North Campus Faculty Housing Phase II  
Project No. FM110407L/986315

**Addendum No. 6**

ADDENDUM NUMBER 6  
to the  
CONSTRUCTION DOCUMENTS

**BUILDING 600A: SECTIONS**

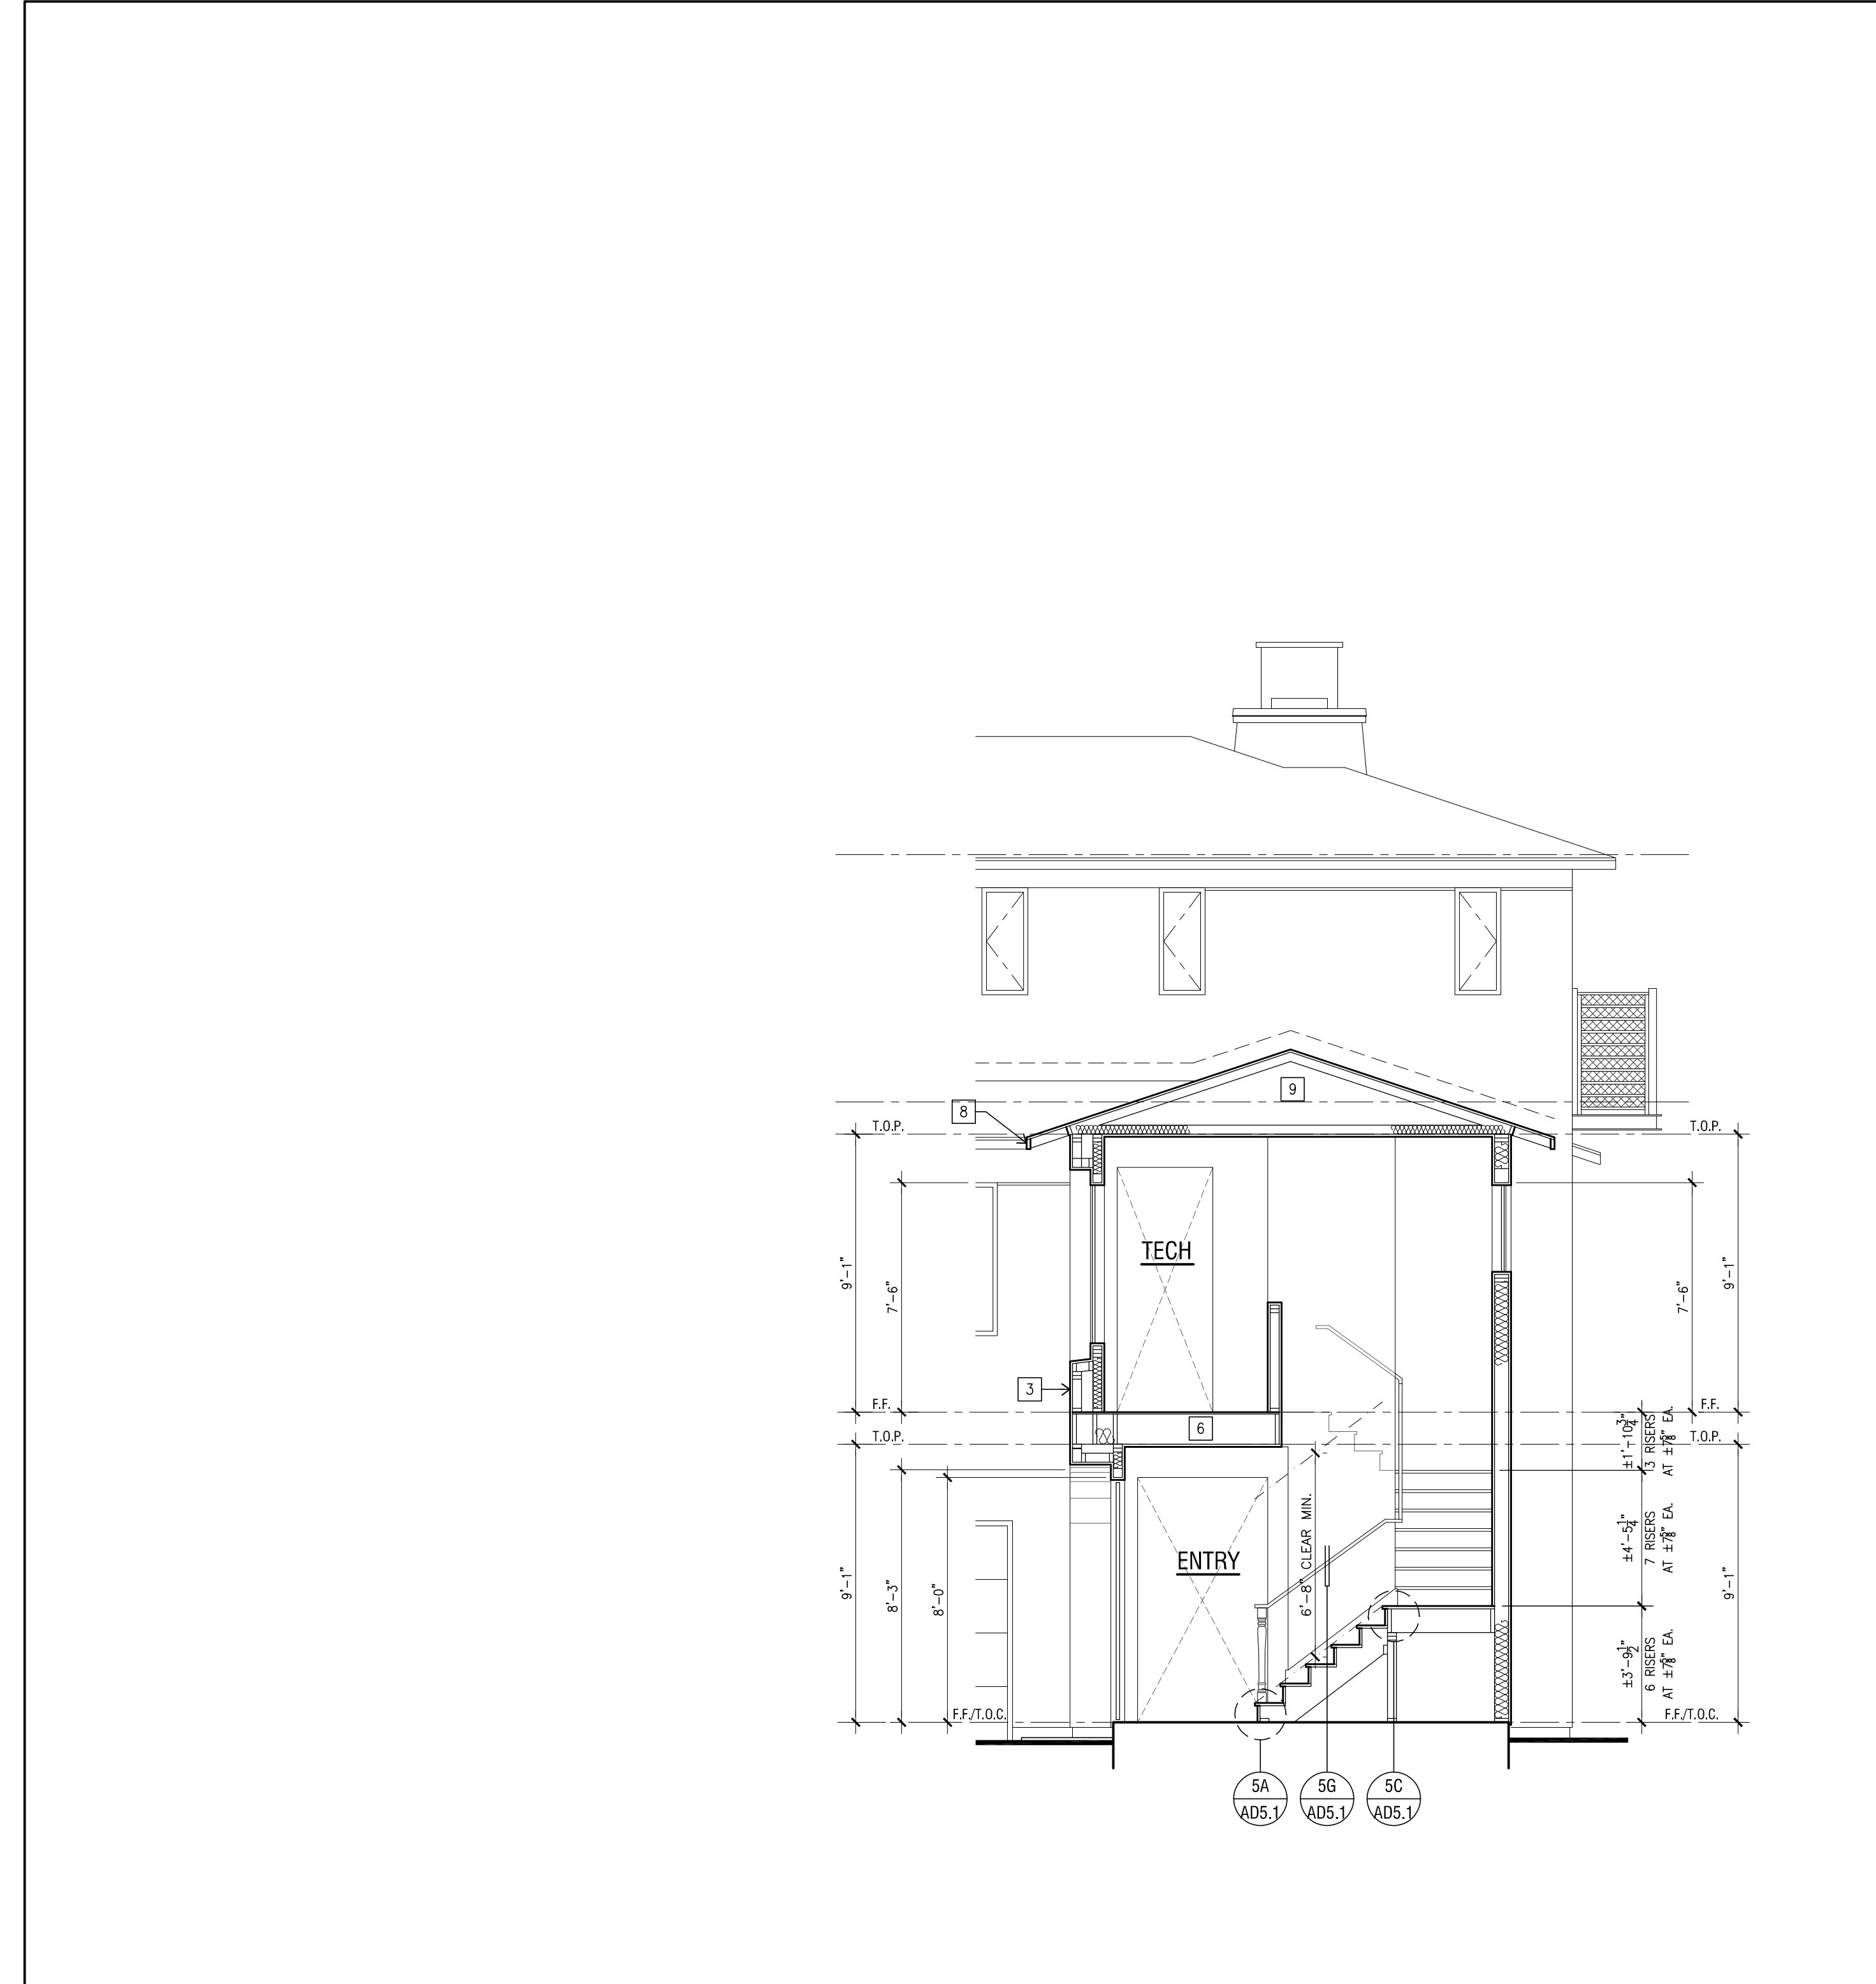
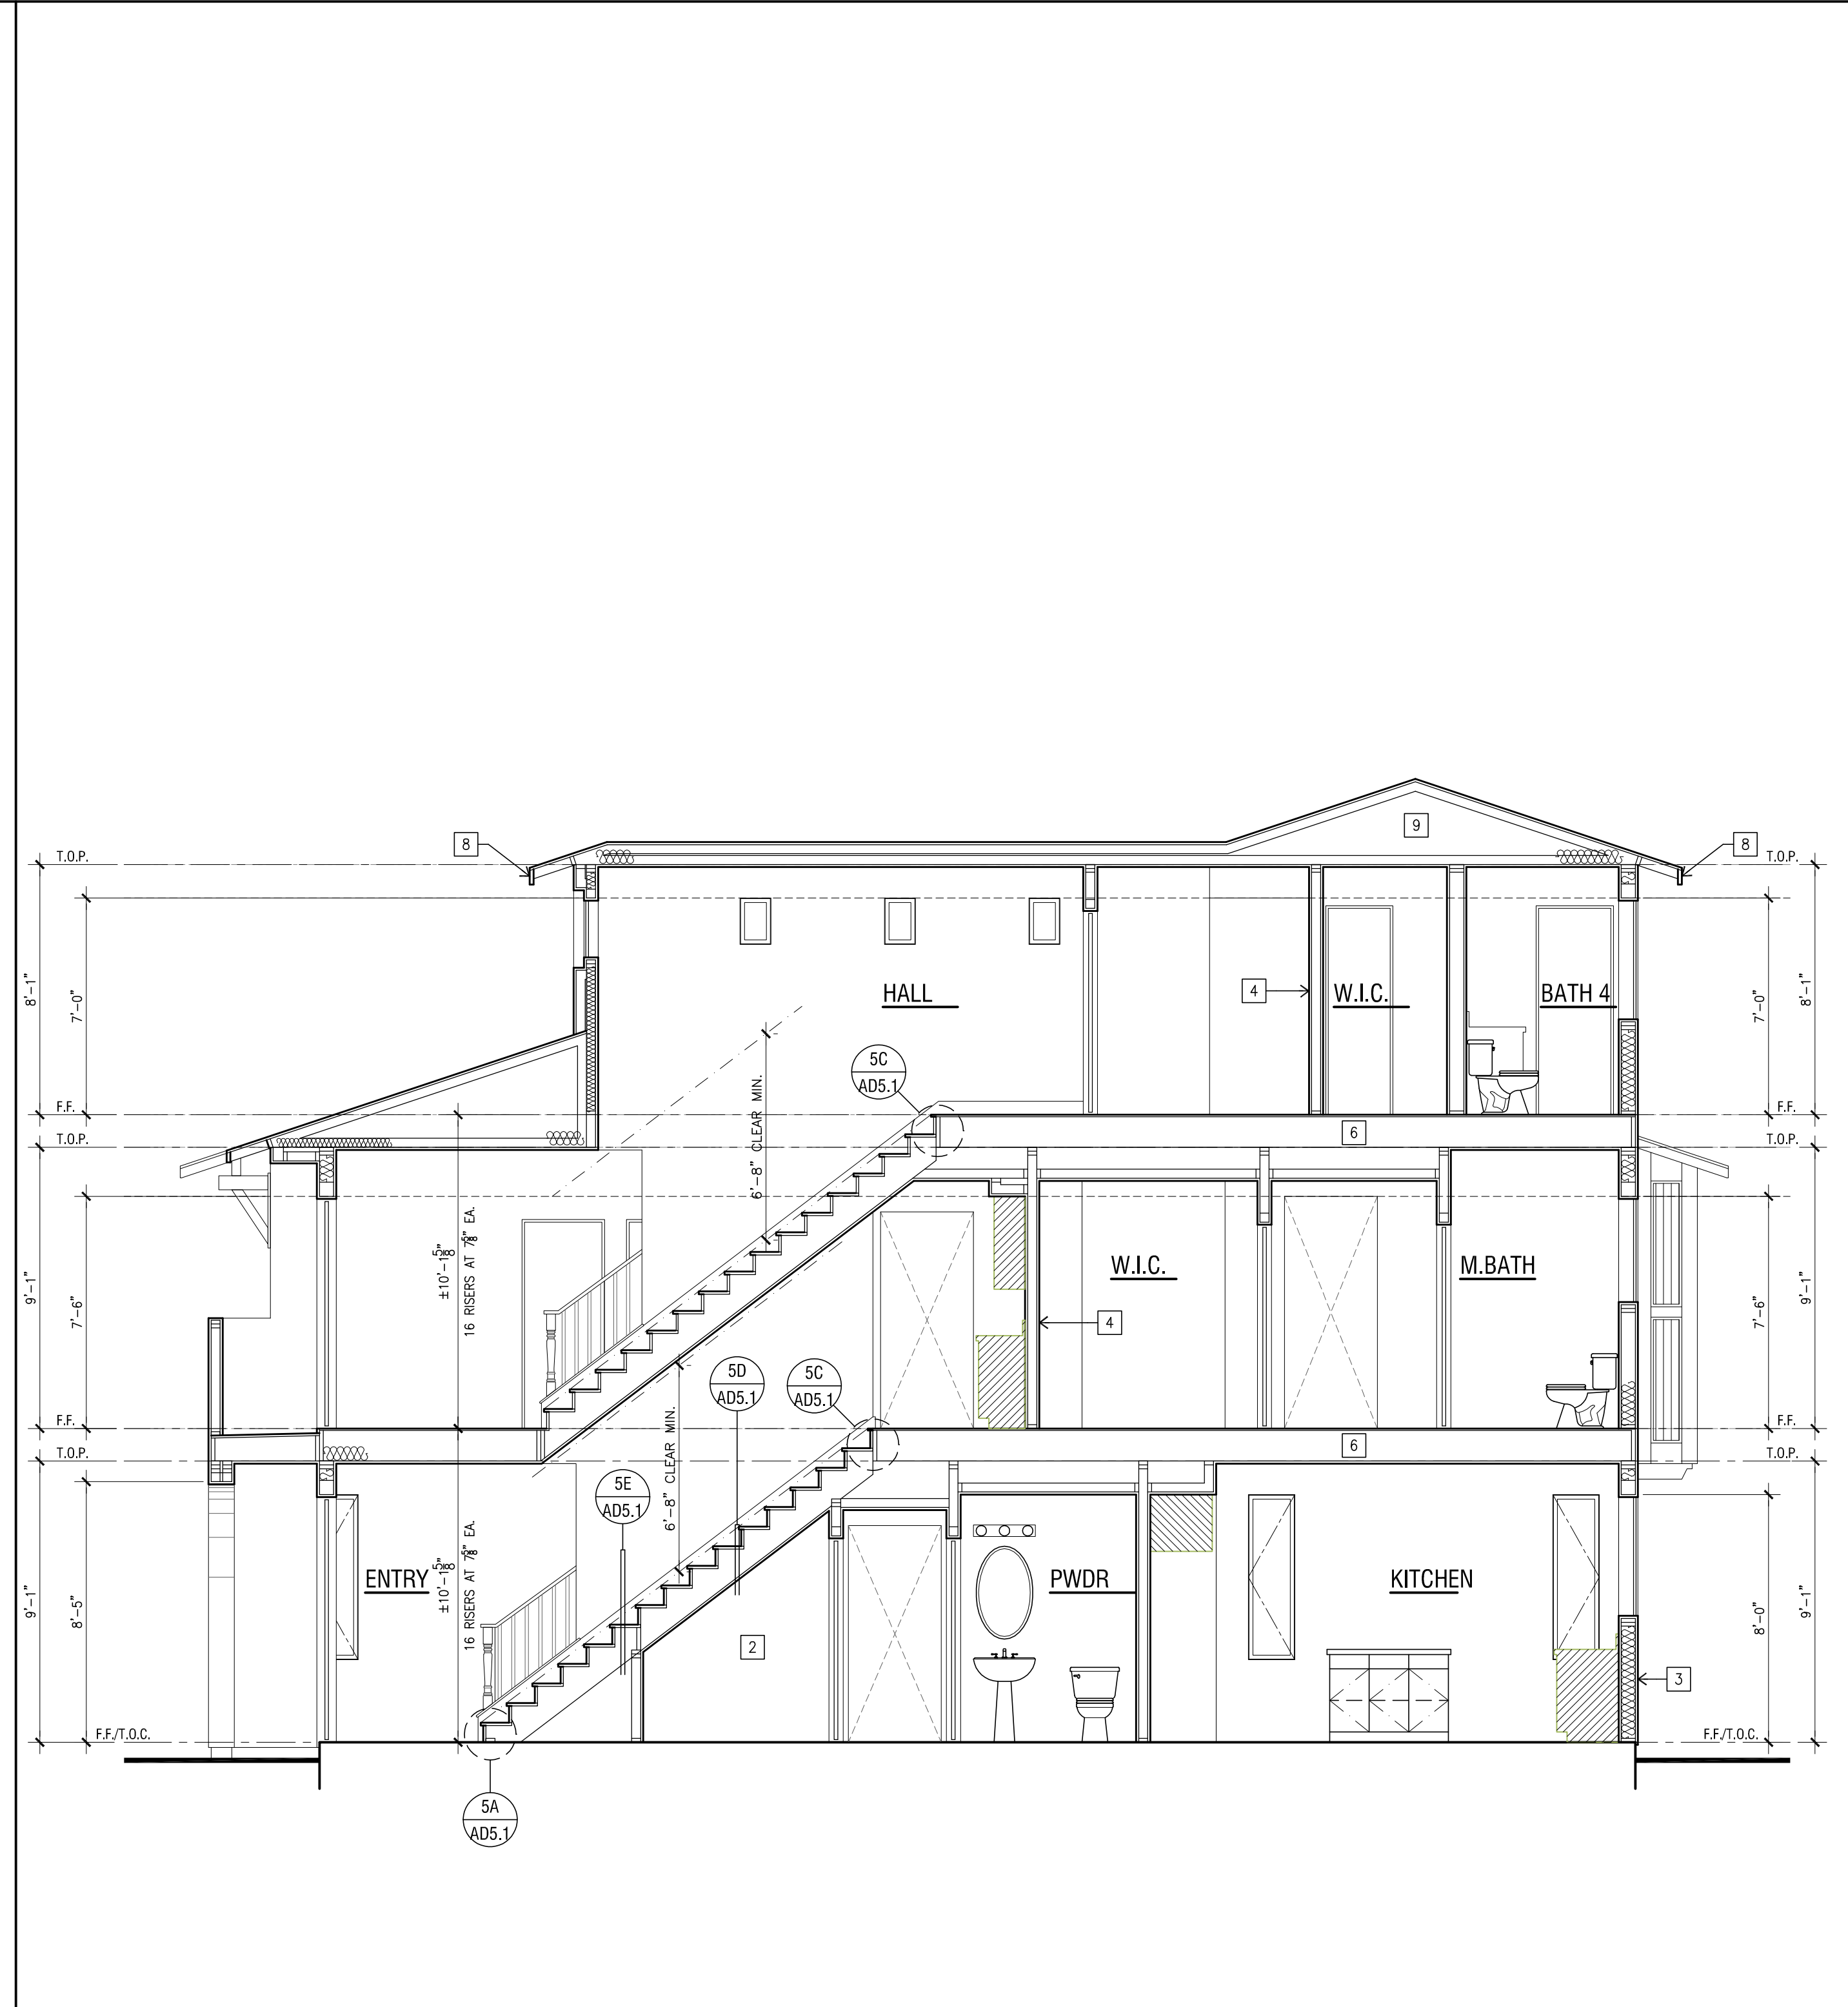
1. **Add** the attached Architect Sketches 1 of 8, dated 9/23/11.  
Sketch 1 of 8 Building 400A: Sections  
Sketch 2 of 8 Building 400B: Sections  
Sketch 3 of 8 Building 500B: Sections  
Sketch 4 of 8 Building 600A: Sections
